COMMONWEALTH OF KENTUCKY  
BEFORE THE KENTUCKY STATE BOARD ON ELECTRIC  
GENERATION AND TRANSMISSION SITING

<i>Electronic</i> Application of Golden Solar, LLC	)	
for Certificate of Construction for an	)	
Approximately 100 Megawatt Merchant	)	Case No.
Electric Solar Generating Facility in Golden	)	2020-00243
County, Kentucky

**Response to Siting Board Staff's First Request for Information**

Figure No.  
**ESB-01-24-1**

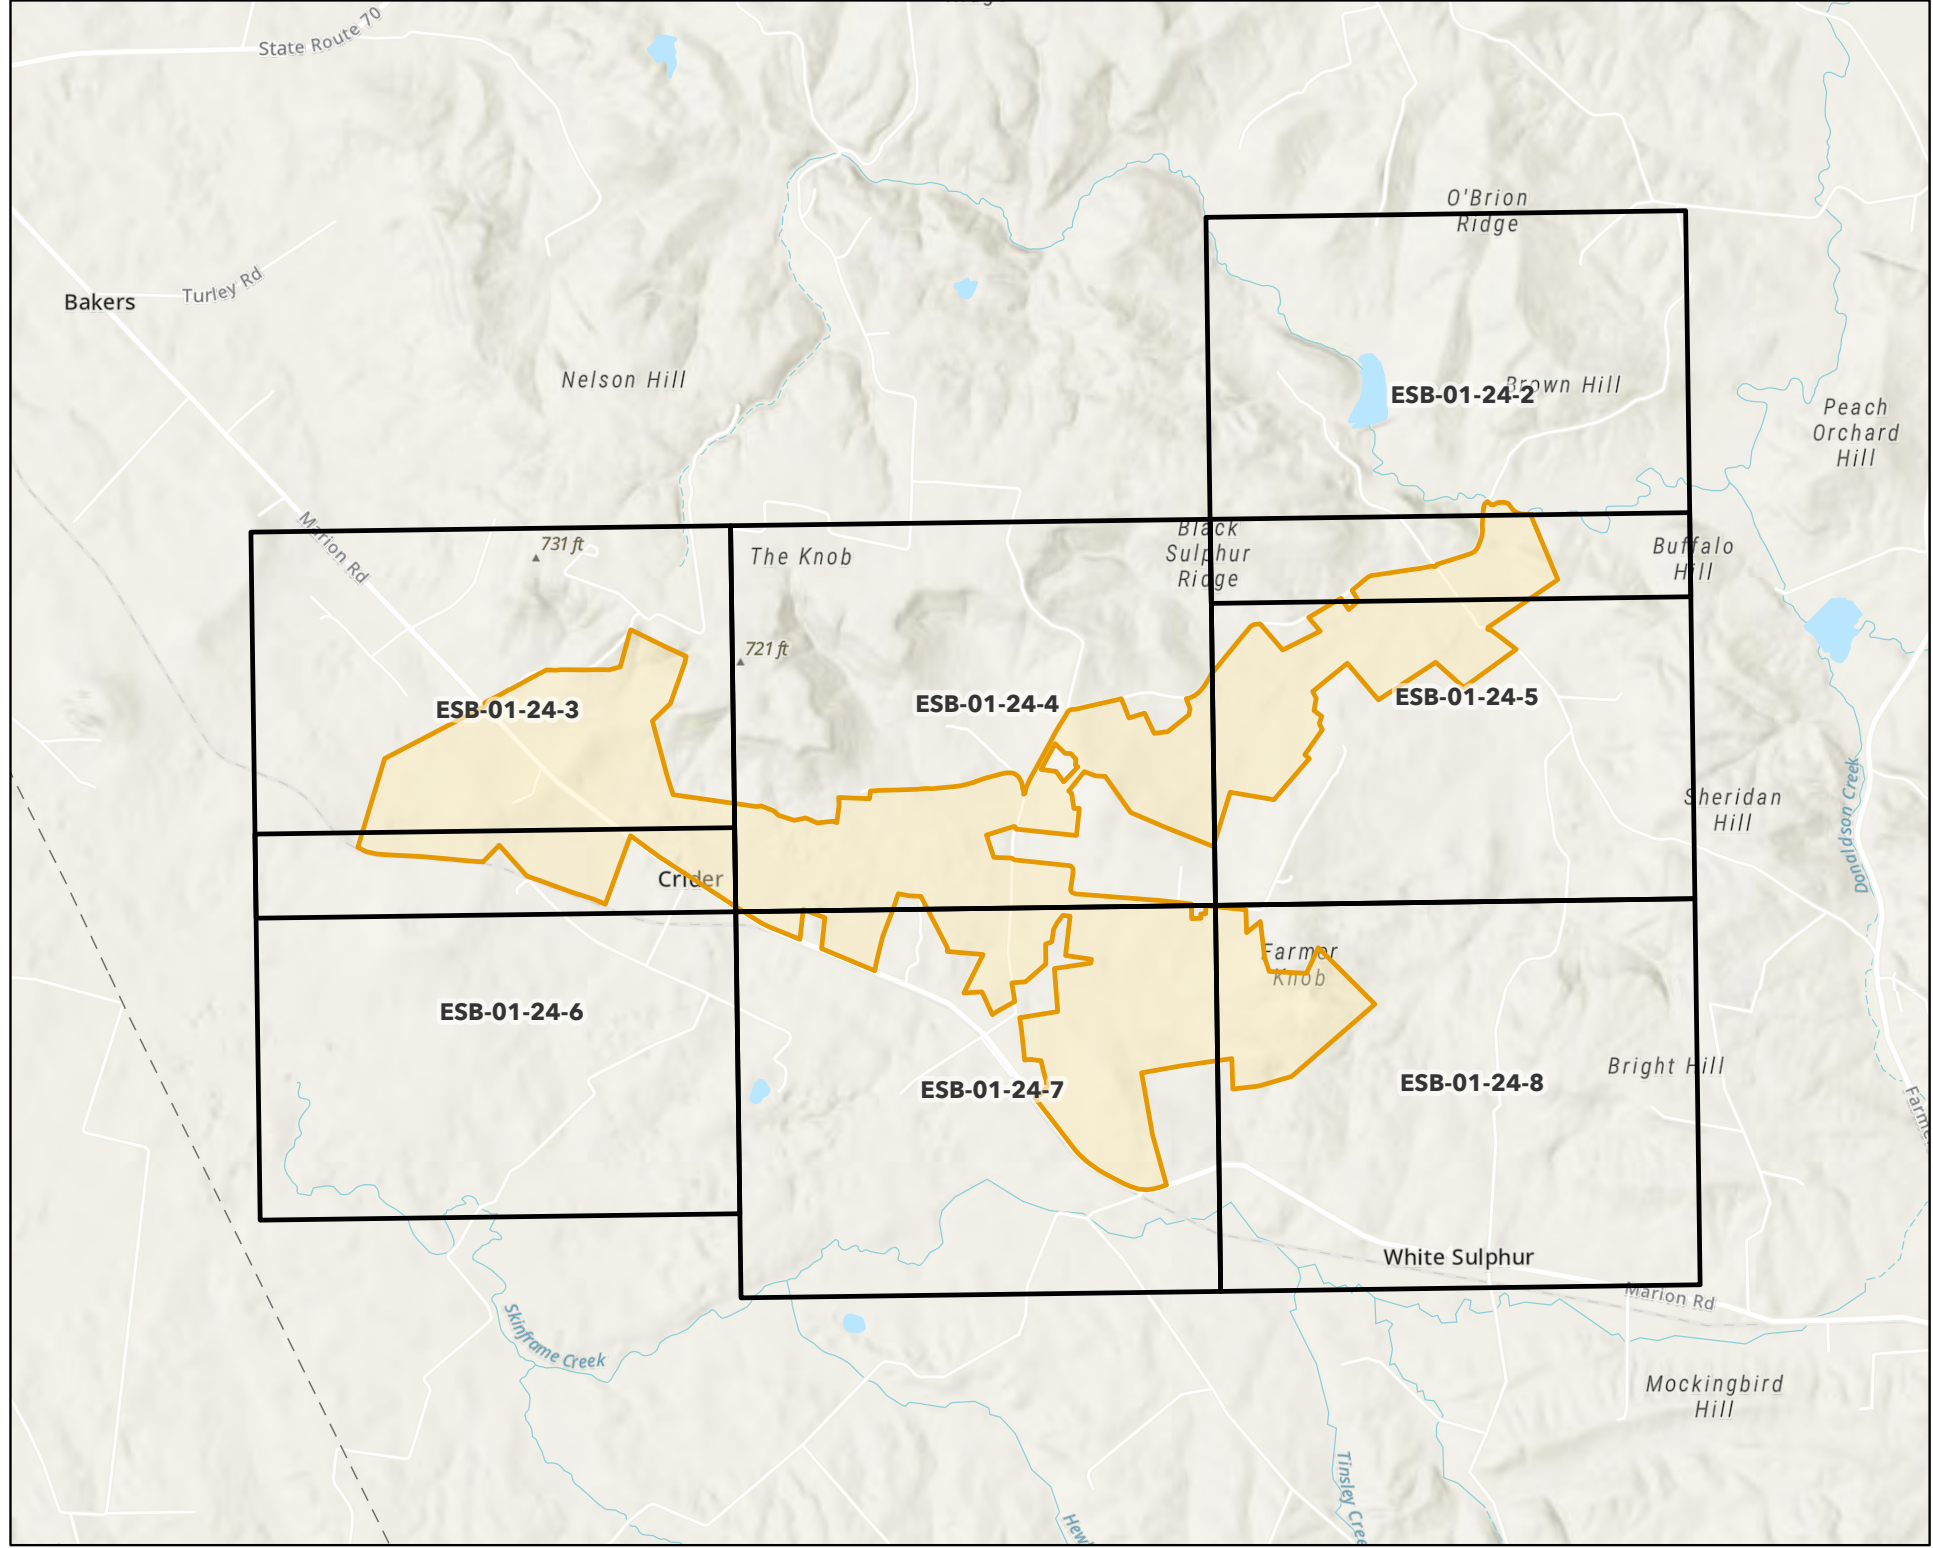
24. Refer to the SAR, Attachment B, Hessler Associates, Inc.'s (Hessler) Report, Page 10, Table 5.0.1.
- a. Confirm that a Vermeer PD10 Pile Driver is the type that Golden Solar will use on this project. If not, identify the type of pile driver that will be used and the associated noise levels produced by that machine.
  - b. Explain how many pile drivers Golden Solar will use at any one time during construction and whether these machines will be used in close proximity to each other at any time, such that the combined dBA sound levels will exceed those listed in Table 5.0.1. If so, provide an updated chart showing the combined dBA sound levels.
  - c. Provide a list of non-participating sensitive noise receptors within 1,500 feet of pile driving construction activity.
-

- a. Yes, a Vermeer PD10 Pile Driver or similar type of pile driver is anticipated to be used.
- b. Golden Solar estimates up to 12 pile drivers could be used across the site at a time, with approximately 2-3 in close proximity to one another. Sound levels will increase incrementally with additional pile drivers operating near each other, but the specific sound levels created would depend on a wide variety of factors and it is not possible to provide an accurate chart for multiple pile drivers operating near each other. Sound levels from pile drivers depend on environmental conditions and the distances from each one to the point of observation. Moreover, available data doesn't provide a clear prediction of sound levels during pile driving activity. The additional sound levels from several pile drivers might increase the total level by 3-5 dBA at a maximum, but the impact on sound levels would depend on how close they were operating and when each machine was driving a pile.
